# ADDENDUM# 1

**DATE:** May 18, 2022

PROJECT NO: 21323

PROJECT: Ogden High School Boiler and ROTC Building HVAC Replacement

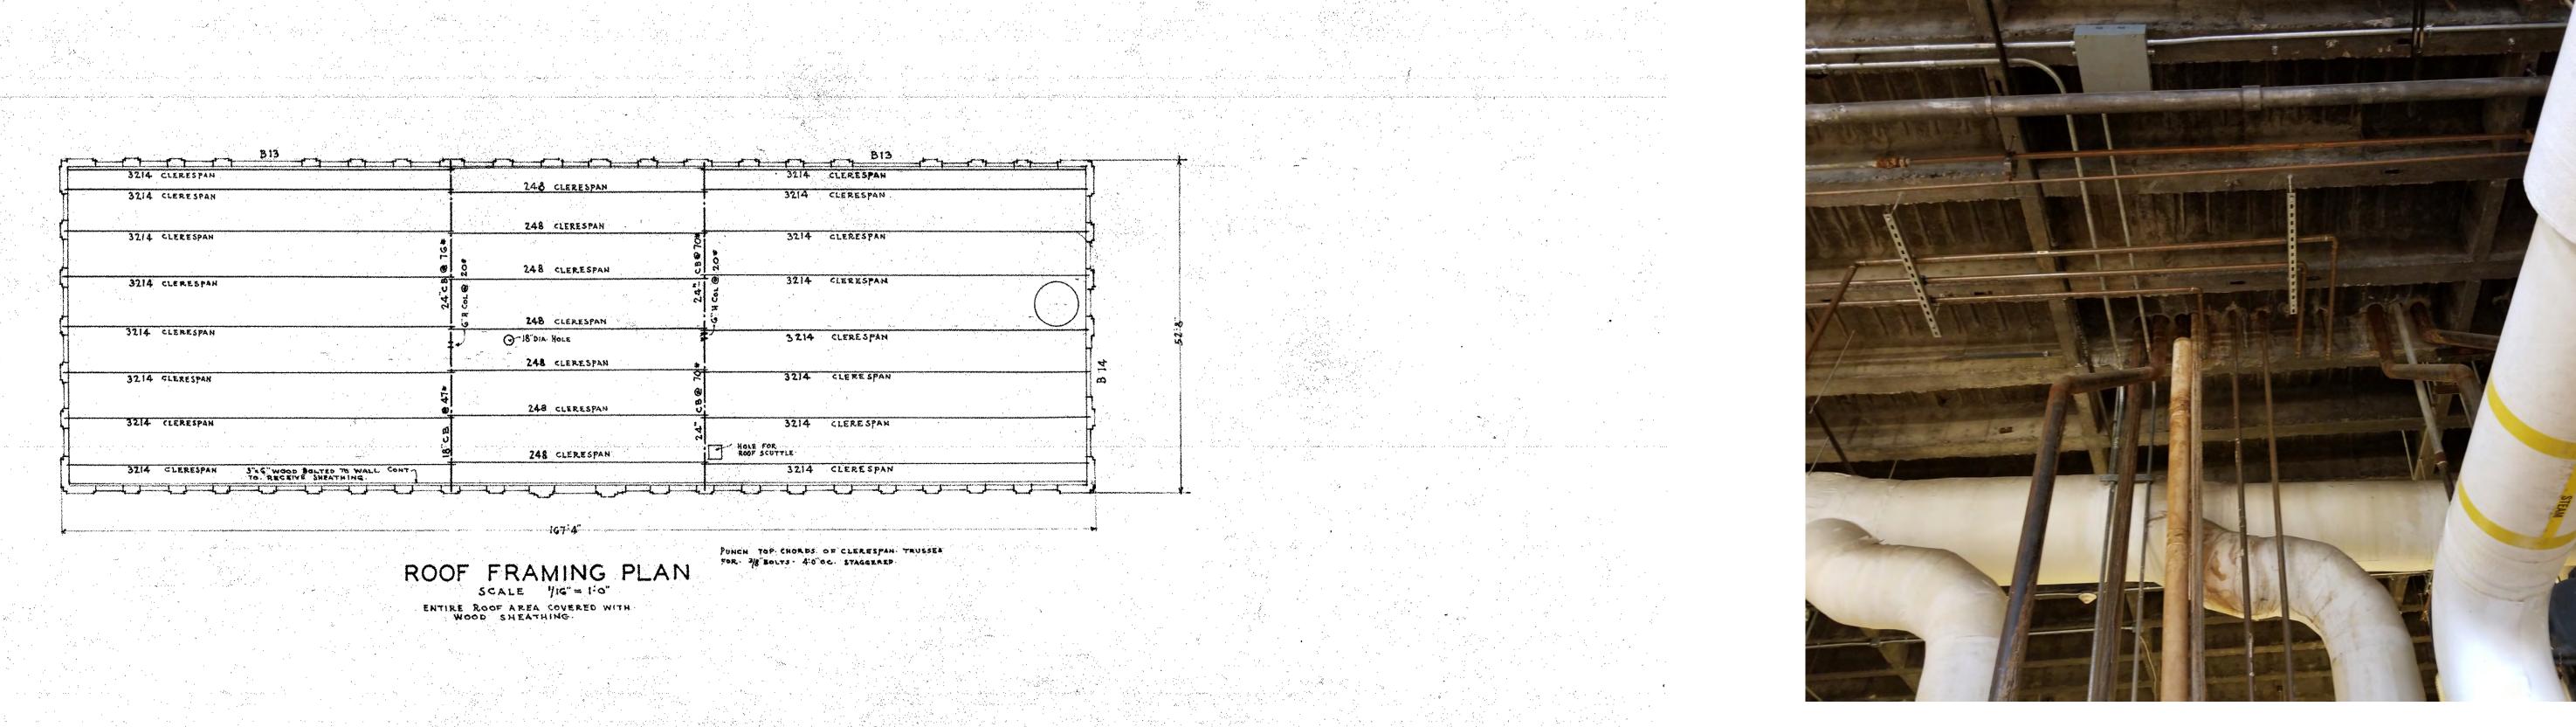
The investigation was limited to reviewing the original building floor framing plan and the (3) new 17" diameter hole penetrations (overlapping existing floor penetrations) in the suspended concrete slab above the new steam boilers, as indicated by VBFA. The (3) new openings will only penetrate the floor slab and not the web or vertical portion of the concrete beams supporting the slab. The distance between concrete floor beams is approximately 2'-3".

The contractor is to locate the (3) new penetrations within the beam spacing indicated in the attached drawings. The new penetrations are to overlap/eliminate the existing pipe penetrations in the same slab without the new penetrations being drilled any closer to the concrete beams below. If the new penetrations are installed in this manner, no additional secondary reinforcement is required around the new floor penetrations.

**M401**

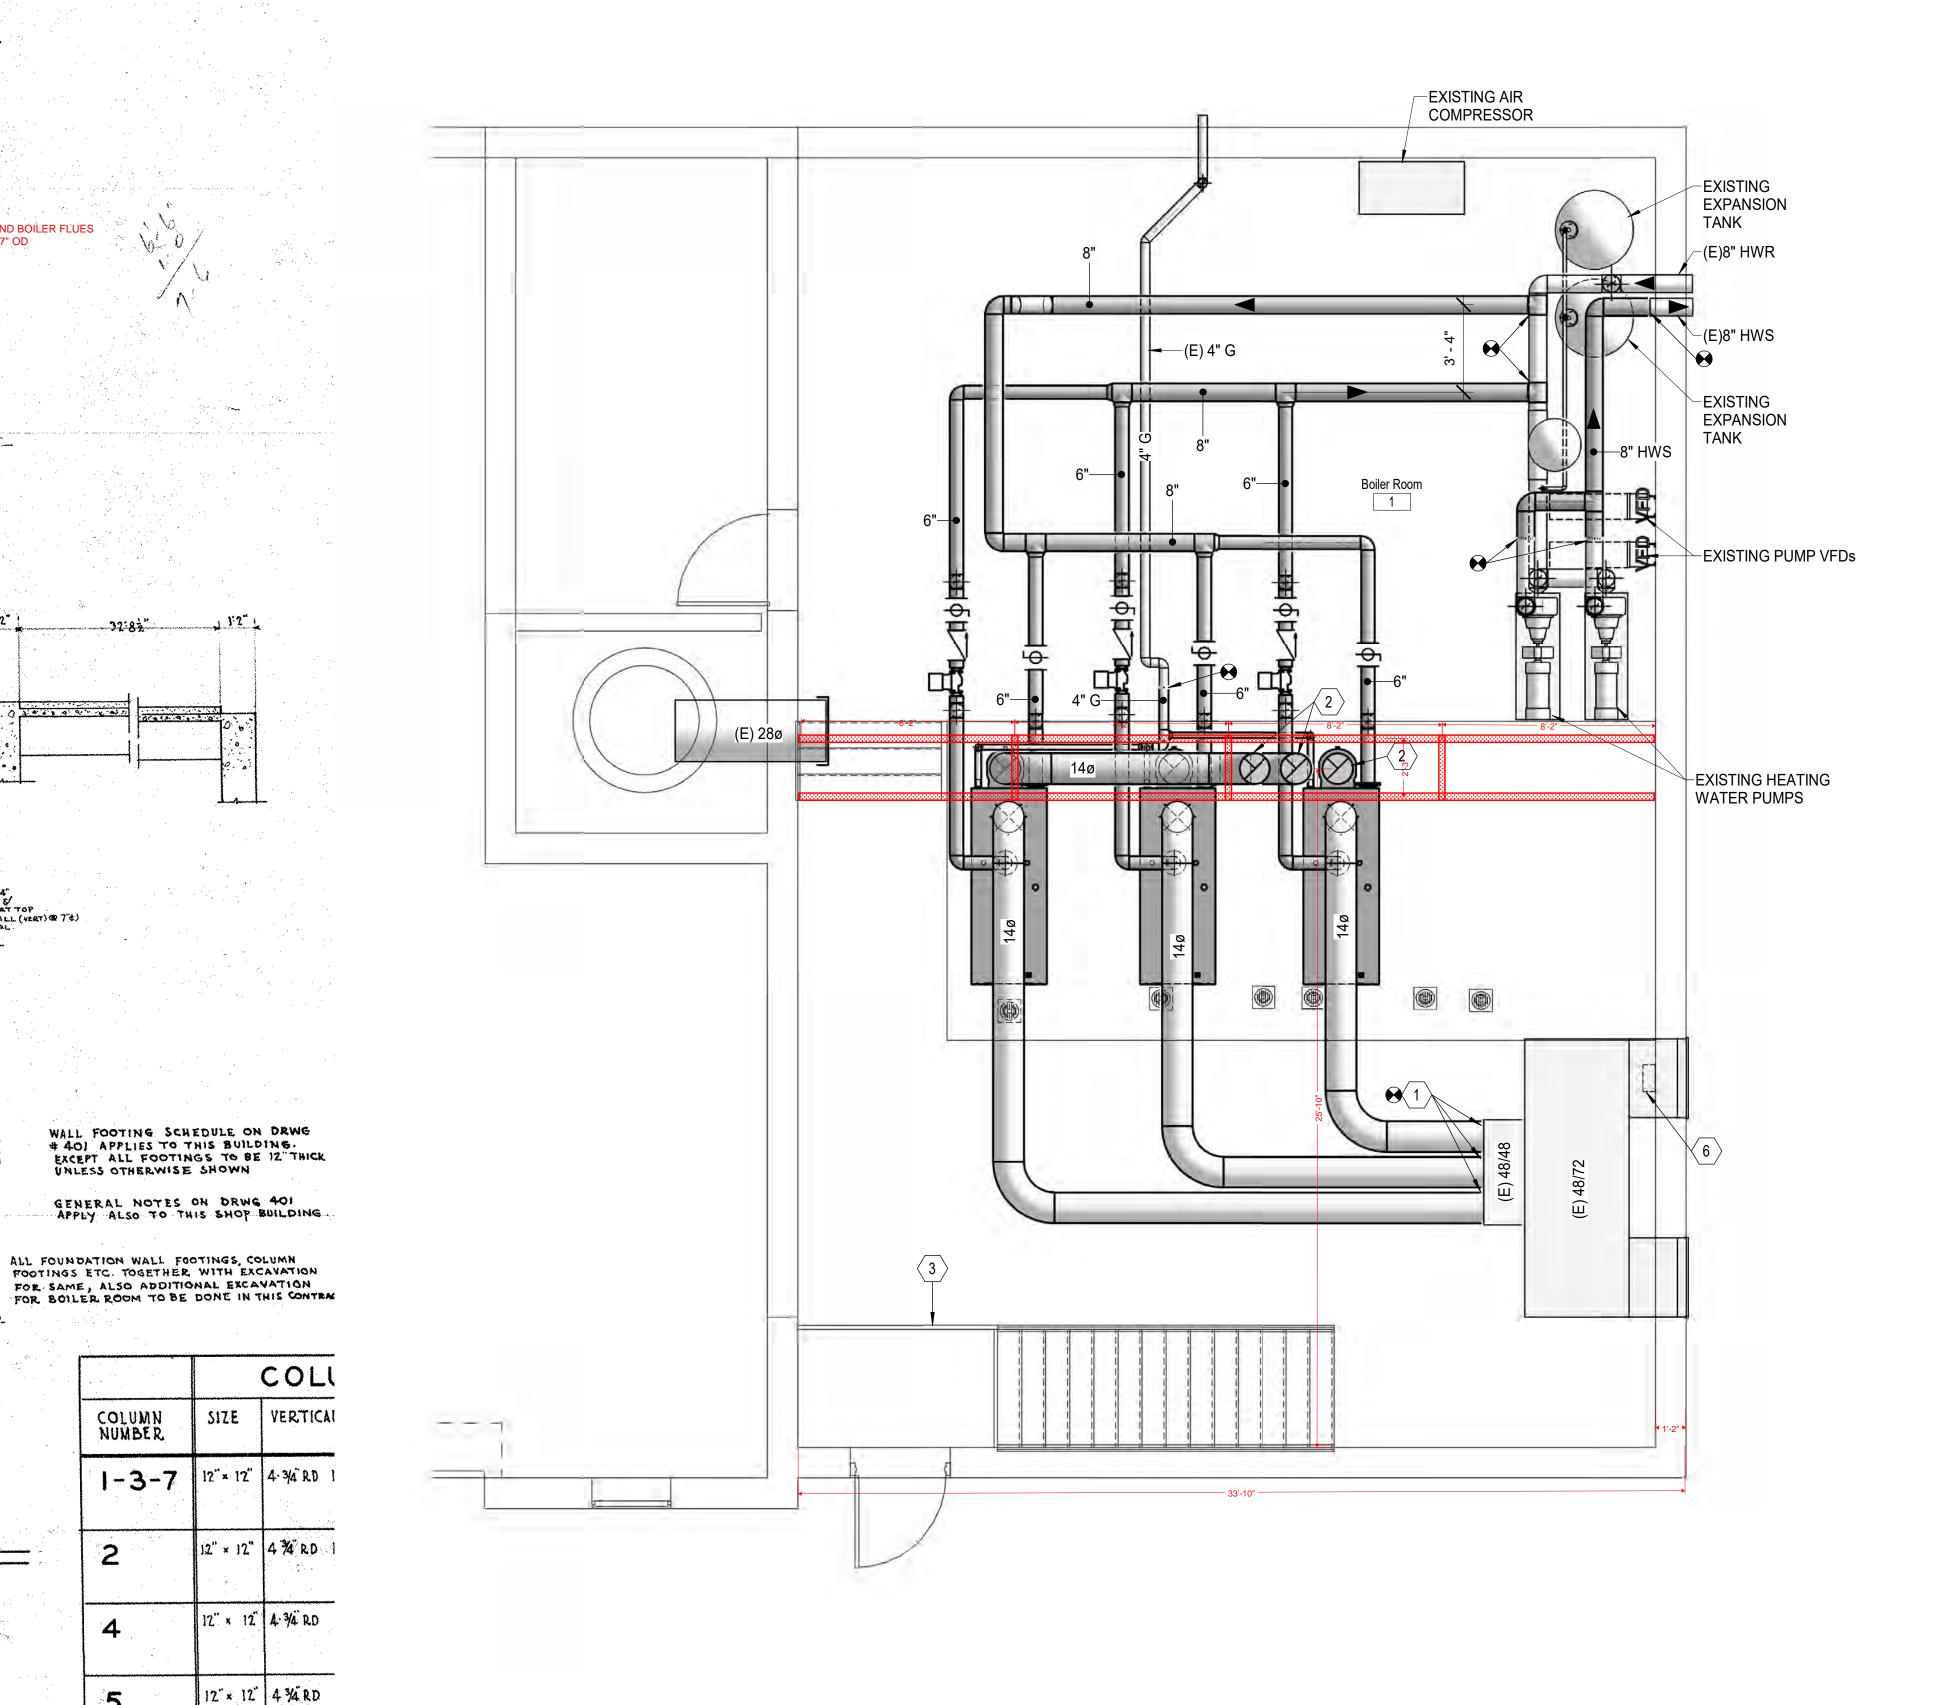
Add to Keyed Note# 2 Refer to Structural Engineers Memorandum for core cut flue openings.
